MODEL BD-100-1A10 (CL-300)

REWORK – WING TANK – ADDITION OF SEALANT TO FACILITATE WATER DRAINAGE FROM WING FUEL TANKS AND PREVENT ERRATIC FUEL INDICATIONS

SERVICE BULLETIN

**REWORK – WING TANK – ADDITION OF SEALANT TO FACILITATE
WATER DRAINAGE FROM WING FUEL TANKS AND
PREVENT ERRATIC FUEL INDICATIONS**

SB100-28-008-70228-A-S2-3

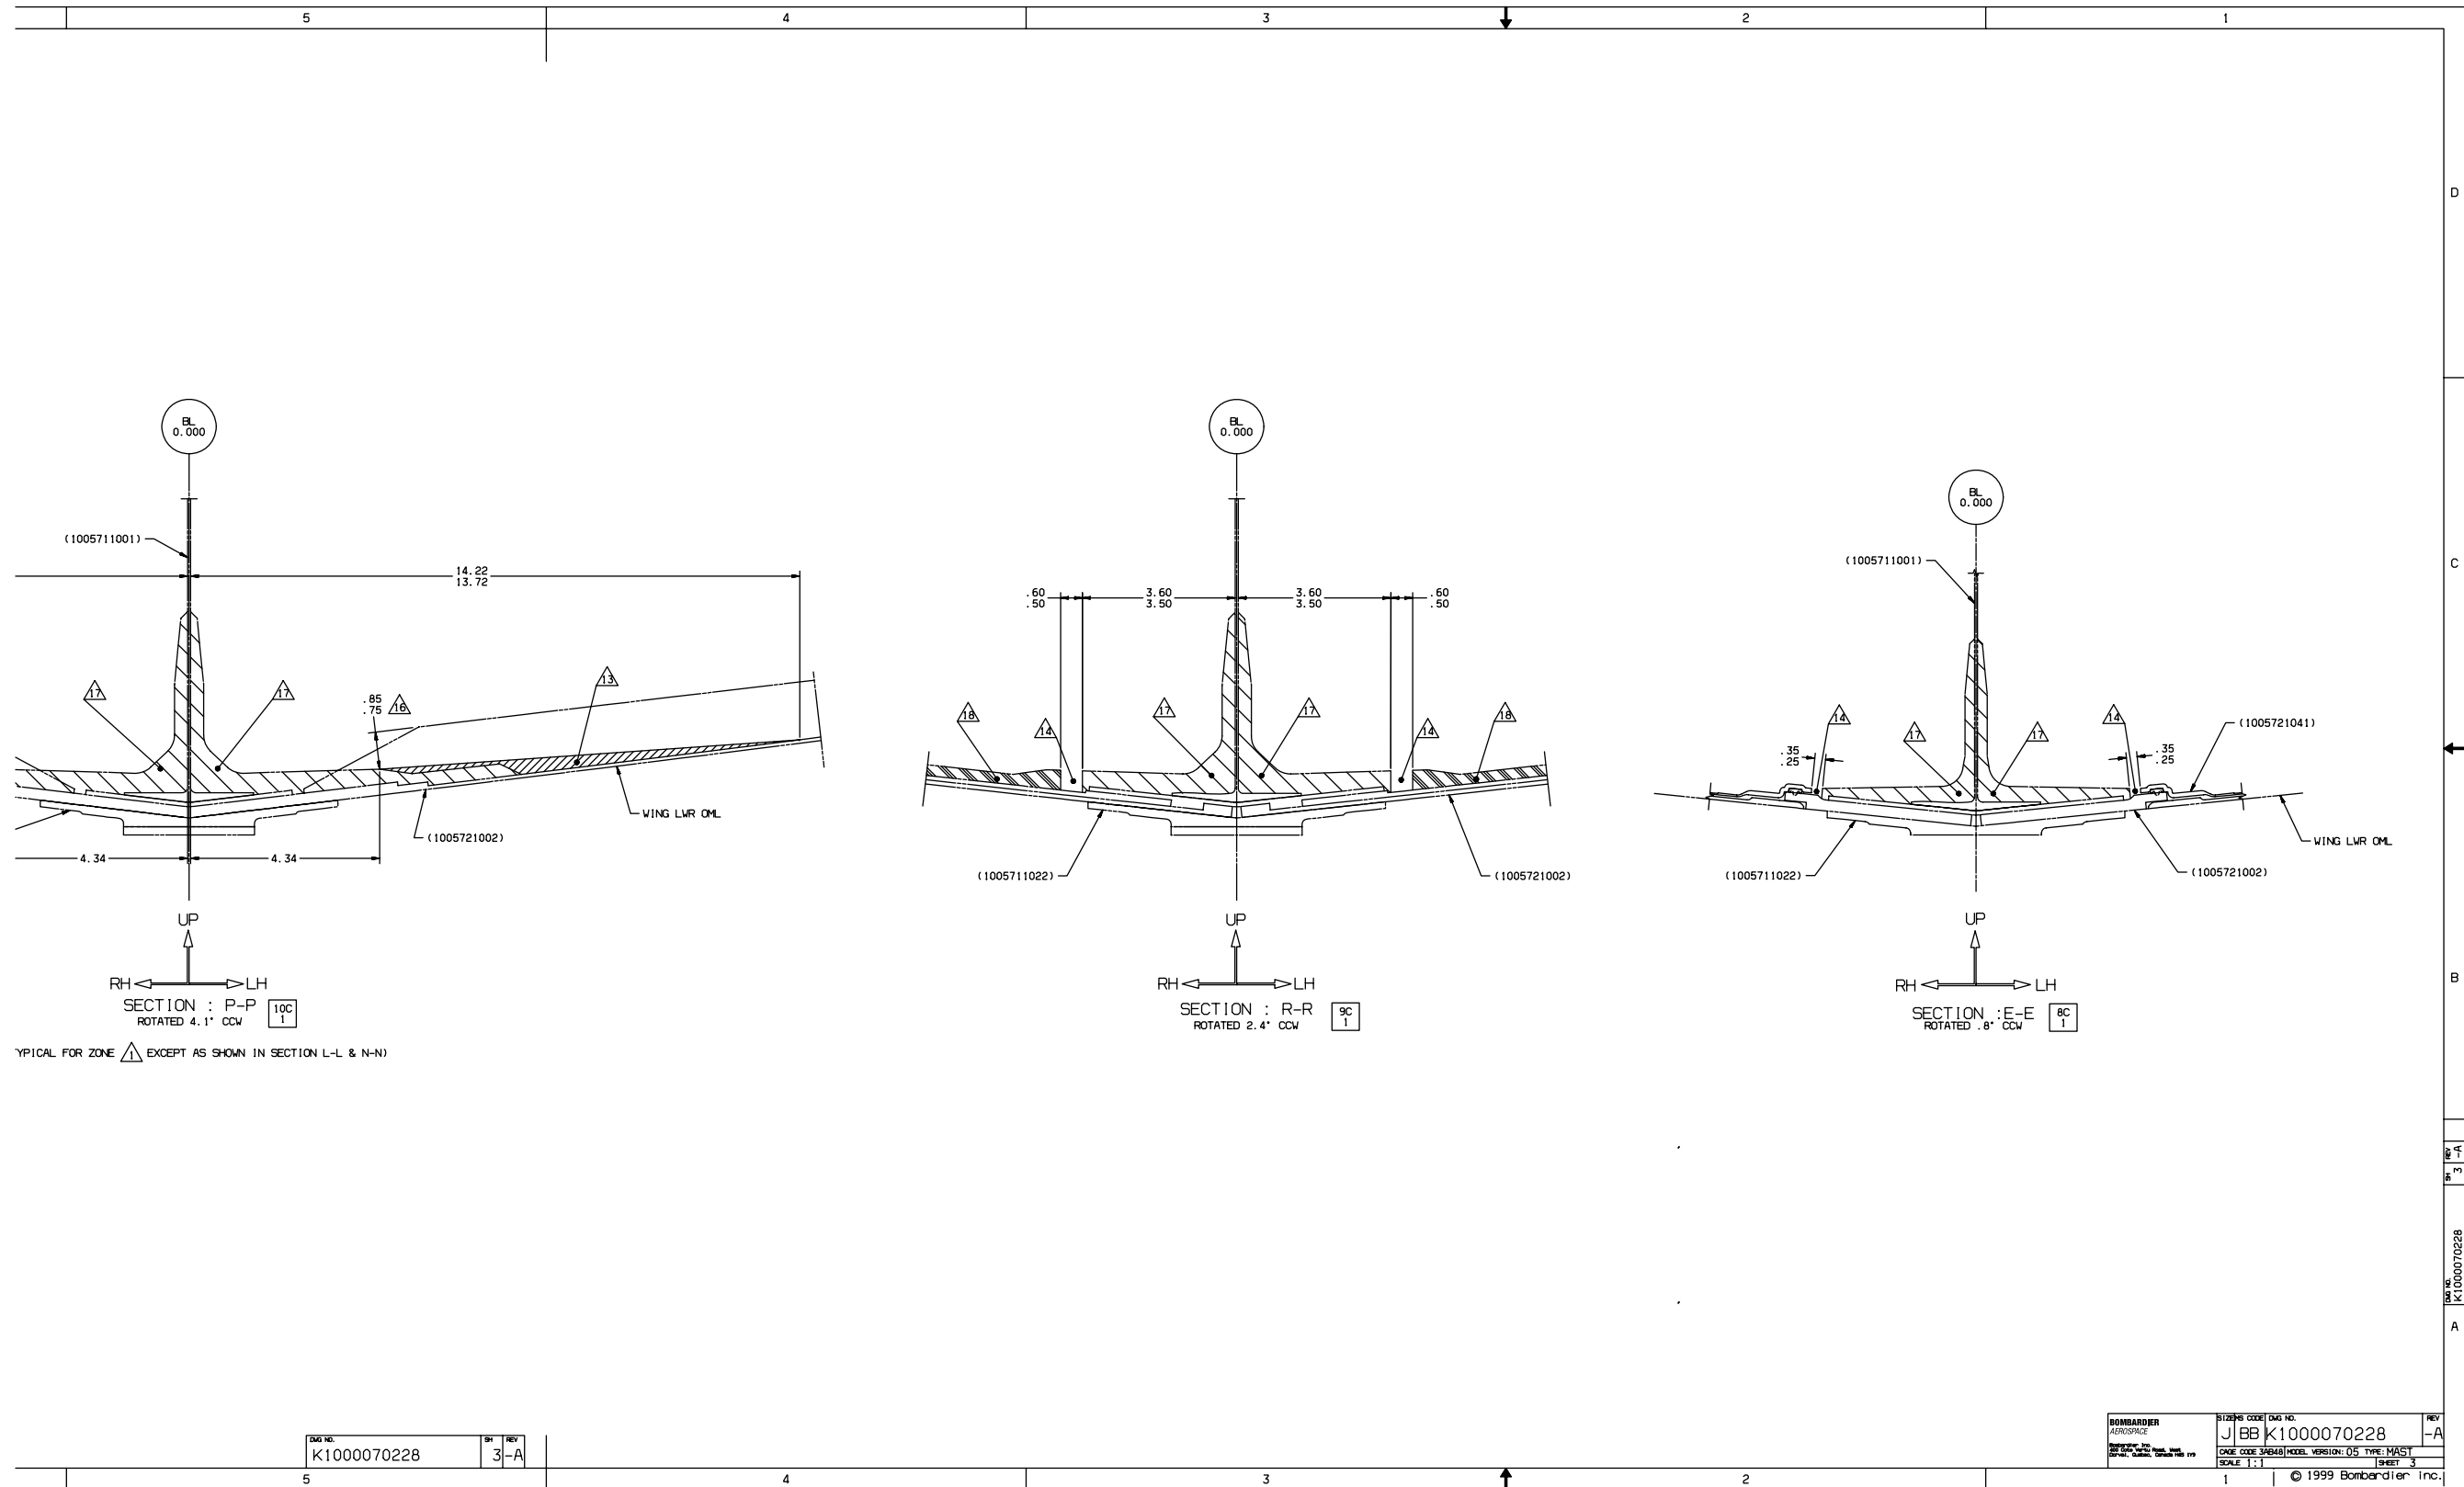
- (4) Verify the thickness of the sealant in the area indicated by flag note 16. The sealant should be at 0.75 to 0.85 inch (19.05 to 21.59 mm) from the top of the stringer. Refer to Kit Drawing K1000070228; section P-P.
 - (a) If the sealant thickness is greater than 0.85 inch (21.59 mm), remove excess sealant using non-metallic tools or Scotch-brite and prepare surface as per Paragraph 2.B.(3). Refer to Kit Drawing K1000070228.
 - (b) If the sealant thickness is less than 0.75 inch (19.05 mm), prepare surface as per Paragraph 2.B.(3). Refer to Kit Drawing K1000070228.
- (5) Inspect the reworked areas for damage to structure or finish before the application of new sealant. If any damage is present, contact Bombardier Aerospace Customer Support Engineering for disposition.
- (6) Inspect the reworked area sealant for damage and good adhesion to structure.

NOTE: Minimum sealant thickness over fasteners is required to meet EMC/Lightning requirements.
- (8) Install thermal insulation sealant, Part No. PR-1429 B-1/2 or PR-1429 B-2 (BAMS 552-006) as per TASK 51-23-00-390-807, in the areas indicated by flag note 13 and 16 as required to provide a smooth and evenly sloped water drainage path. Refer to Kit Drawing K1000070228; view A-A, sections L-L, N-N, and P-P.
